<b>Flight Procedure Tracking Form</b>		<b>Action:</b> FLIGHT CHECK	<b>Task Type:</b> IAP	<b>Date Open:</b> 05/27/2014	<b>Task #:</b> 2014052728424301004	<b>Request #:</b> 20140527284243	
<b>Procedure:</b> RNAV (GPS) RWY 31 ORIG			<b>Airport ID:</b> PADU	<b>Airport:</b> UNALASKA		<b>Reimbursable #:</b> NO	
<b>City:</b> UNALASKA	<b>ST:</b> AK	<b>GPS #:</b>	<b>Estimated Chart Date:</b> 07/21/2016		<b>FICO #:</b>		
<b>Fac ID:</b> N/A		<b>Fac. Type:</b>		<b>Specialist:</b> COLTON CROWDER			
<b>Procedure Review</b>							
	<b>Rec'd</b>	<b>Rel'd</b>	<b>Full Name</b>	<b>Comments</b>			
<b>Lead:</b>	12/23/2015			<div>QUALITY</div> <div>10</div> <div>CHECKED</div>			
<b>QA:</b>							LCB 05/04
<b>Liaison:</b>							
<b>Procedure Comments:</b>			<b>Remark Type:</b> INFORMATION				
ENROUTE-NON SPECIAL PROCEDURE ASSIGNED MAGVAR: PADU OLD 14E - NEW 9E 8260-1(S): 6 PENDING DATA USED FOR PADU AIRPORT. 06/14/16: THIS IS A CORRECTED COPY OF THE FORM APPROVED ON 05/10/16. 1. ADDED CHART NOTE: CIRCLING NA. 2. ADDED CHART NOTE: FINAL COURSE DOES NOT MEET RUNWAY ALIGNMENT STANDARDS. 3. ADDED CAUTION VERBIAGE IN MISSED APPROACH INSTRUCTIONS. 4. DELETED DUPLICATE PROCEDURE NA AT NIGHT NOTE. CONTACT: JOHNN

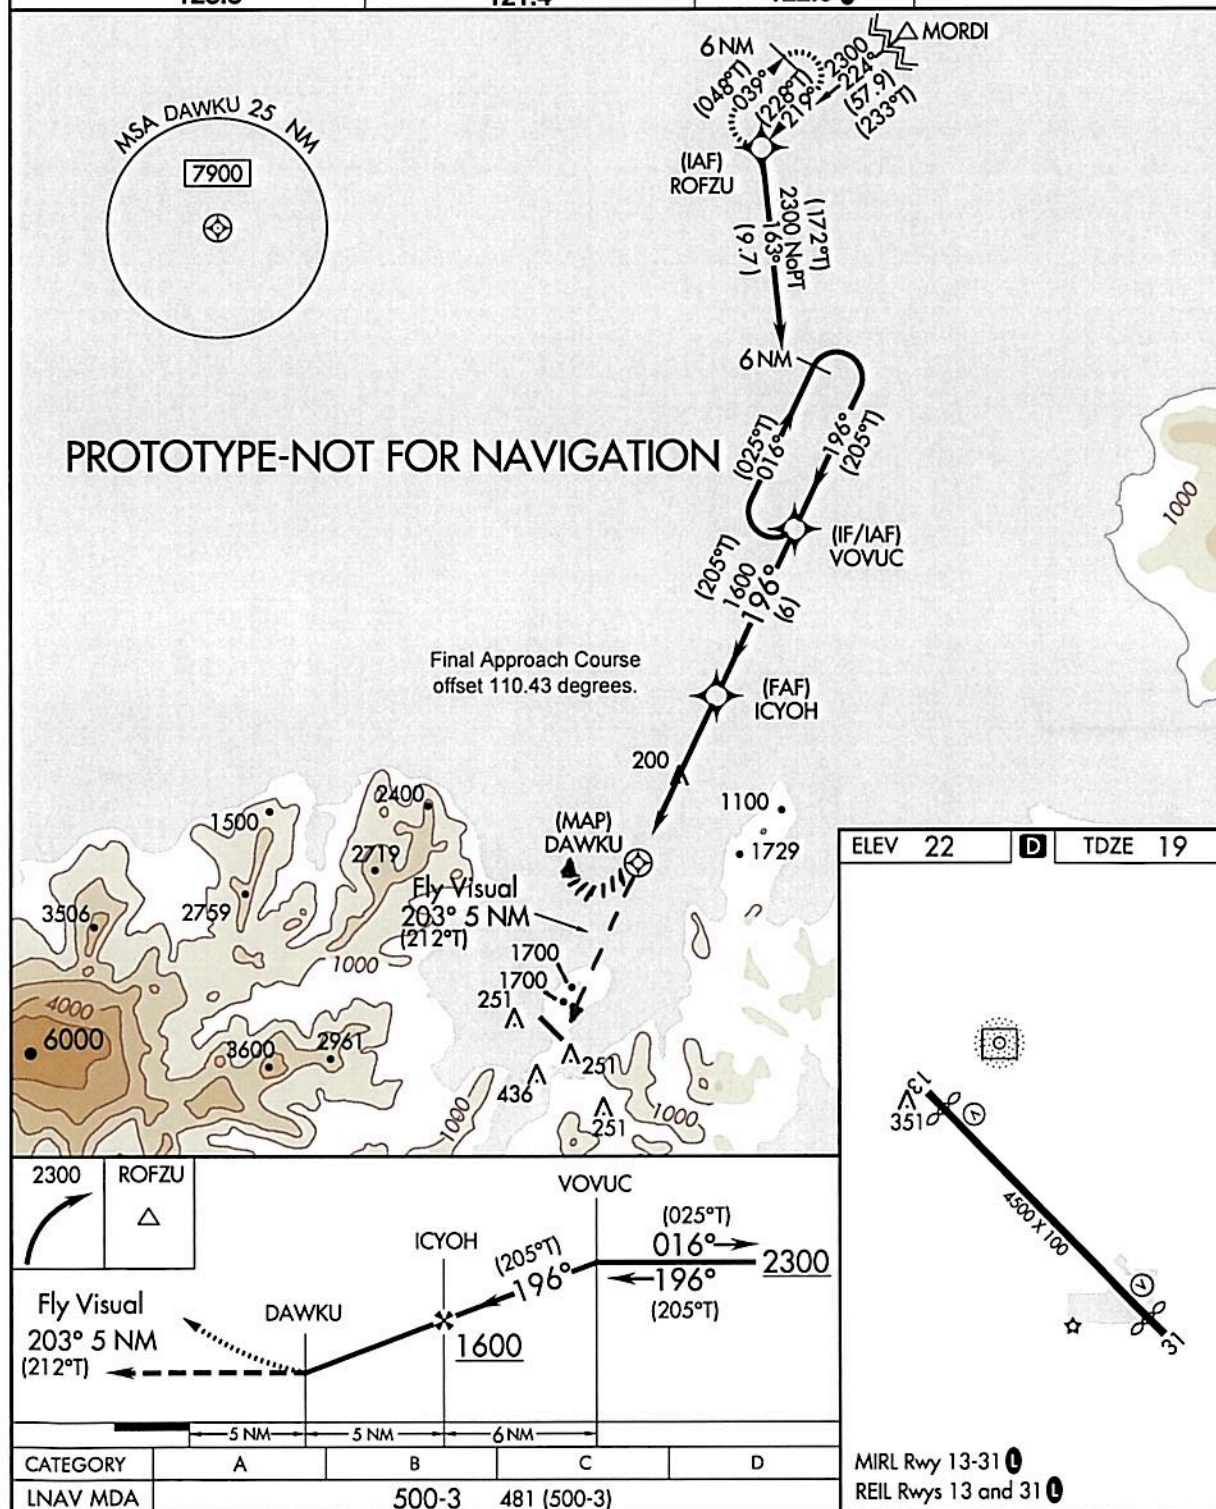
06/28/16: THIS IS A CORRECTED COPY OF THE FORM APPROVED ON 05/10/16.

1. DELETED MISSED APPROACH CAUTION NOTE: ANY GO-AROUND AFTER PASSING THE MAP WILL NOT PROVIDE STANDARD OBSTRUCTION CLEARANCE.

**NA** DME/DME RNP-0.3 NA. Procedure NA at night. Circling NA. Final course does not meet runway alignment standards. If Amaknak Island not sighted at MAP, execute missed approach. Use of this procedure requires specific authorization by FAA Flight Standards. Activate MIRL Rwy 31-CTAF. When local altimeter setting not received, use Akutan altimeter setting and increase all MDA 100 feet.

**MISSED APPROACH:** Climbing right turn to 2300 direct ROFZU and hold. Do not exceed ground track radius of 1.5 NM.
